## HONEYWELL VK GAS VALVE

FOR VISION® RADIANT TUBE HEATERS

### NOTIFICATION BULLETIN

Document reference number TB/093/0914  
Replaces TB/093/0813

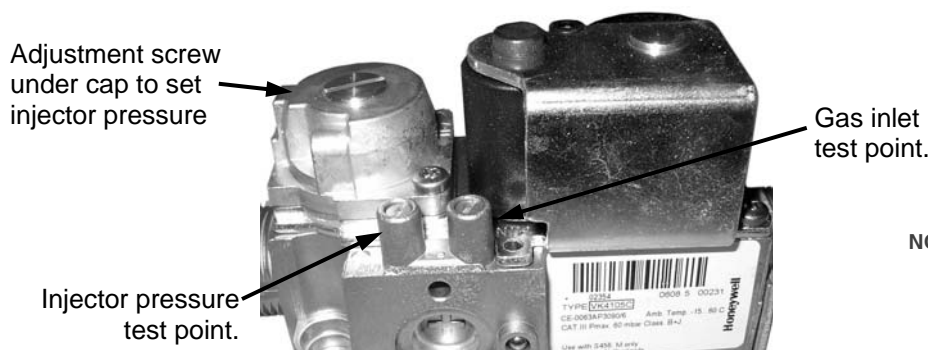
Burners fitted with the new Honeywell valve will be labelled with generation code: AB so that the valve can be identified for spares purposes. Example burner label shown below:

**For spares purposes:** Only Vision burners currently fitted with White Rogers gas valves part Nos. 202404 and 202528 with generation code 'AA' can be replaced with the new Honeywell gas valves.
